**Cogentrix Quail Brush Generation Project - Docket Number 11-AFC-03:
Addendum to the Re-Study of C1C2 Phase II Interconnection Study**

Addendum to Re-Study of C1C2 Phase II Appendix A – C565 Individual Project Report

Quail Brush Generation Project

October 22, 2012

Figure 2.1: Interconnection Facilities and Reliability Network Upgrades for Revised POI

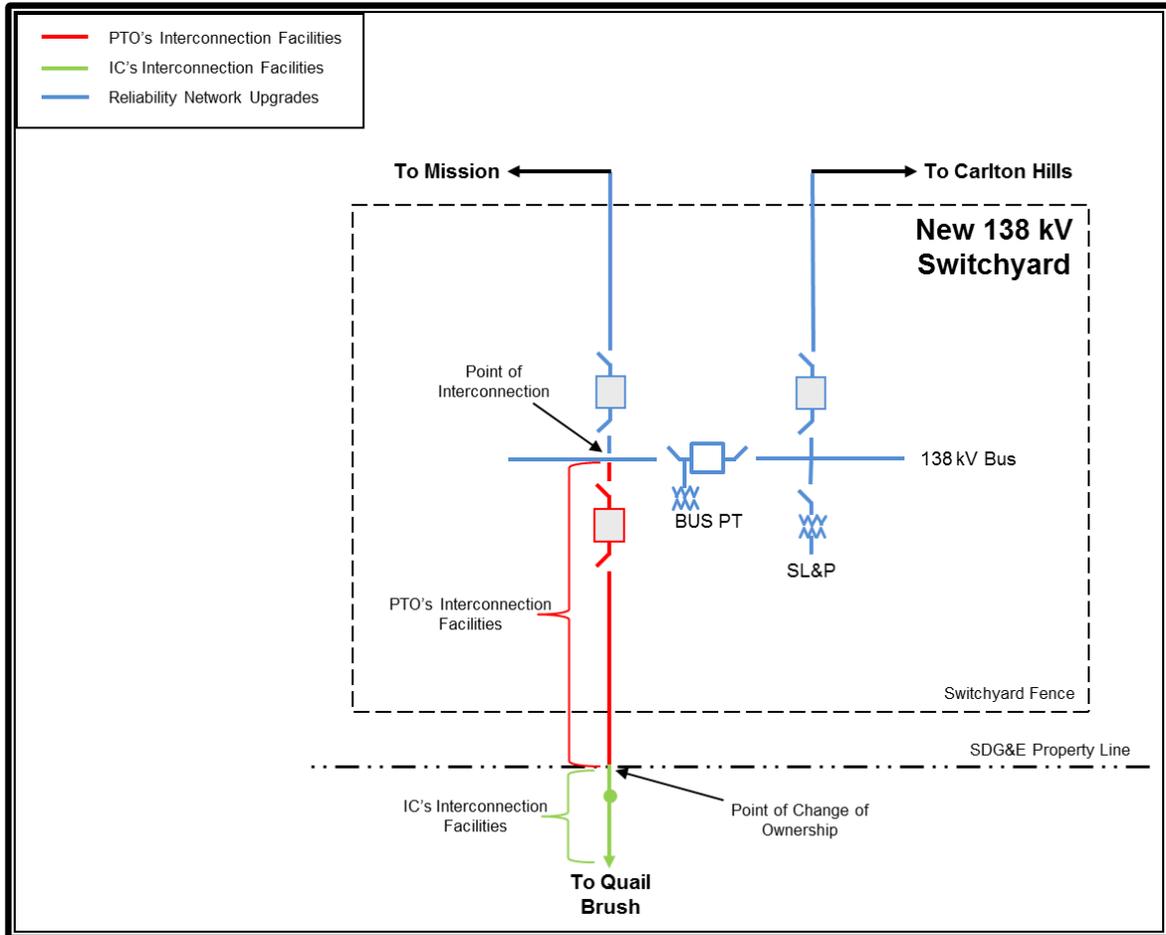
C. Replace Figure 2.1 on page 5 to reflect the change in POI
